Access Compliance Report Public Rights-of-Way (Curb Ramps)

Main Street: RED_HILL_AVE	Cross Street: N/A	Location: W
---------------------------	-------------------	-------------

ADA ID: RPRK220107115255	Ramp Type:Type 1 - Perpendicular	Initial Pass/Fail: Fail	Overall Compliance: No	Severity Score: 2
--------------------------	----------------------------------	-------------------------	------------------------	-------------------

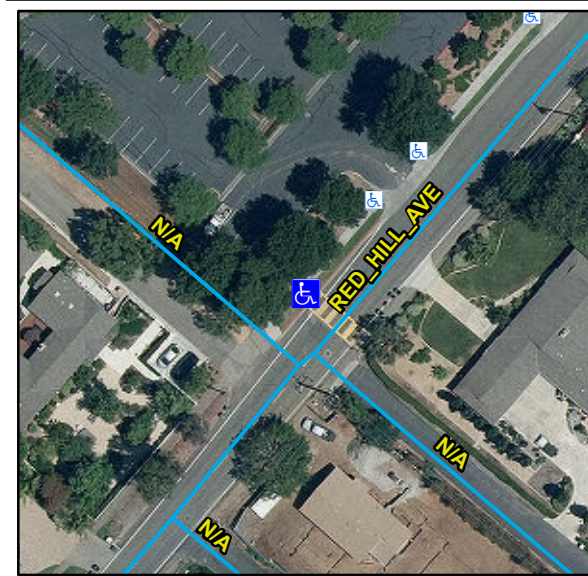
Compliance	Description	Data	Compliance	Description	Data
N/A	Ramp Length (in)	56	N/A	Flare Type LT	
Yes	Ramp Width (in)	48			N/A
Yes	Ramp Run Slope (%)	7.2	N/A	Flare Slope LT (%)	N/A
No	Ramp Cross Slope (%)	3.2	N/A	Flare Traversable LT	N/A
N/A	Landing Present	N/A	N/A	Flare Type RT	
N/A	Landing Length (in)	N/A			N/A
N/A	Landing Width (in)	N/A	N/A	Flare Slope RT (%)	N/A
N/A	Landing Run Slope (%)	N/A	N/A	Flare Traversable RT	N/A
N/A	Landing Cross Slope (%)	N/A	N/A	DWS Provided	N/A
N/A	Landing Movement Obstructed?	N/A	N/A	DWS Contrast	N/A
	Landing Movement Type	N/A	N/A	DWS Length (in)	N/A
N/A	Landing Shared	N/A	N/A	DWS Full Width	N/A
N/A	Clear Space	N/A	N/A	DWS Offset Left (in)	N/A
N/A	Clear Space To Crosswalk (in)	N/A	N/A	DWS Offset Right (in)	N/A
N/A	Marked Crosswalk 1	Yes	N/A	Marked Crosswalk 2	N/A
	Crossing 1 Direction	SE		Crossing 2 Direction	N/A
	Marked Crosswalk 1 Width (in)	144		Marked Crosswalk 2 Width (in)	N/A

Remove & Replace Entire Ramp.

R304.5.3, STD 1115
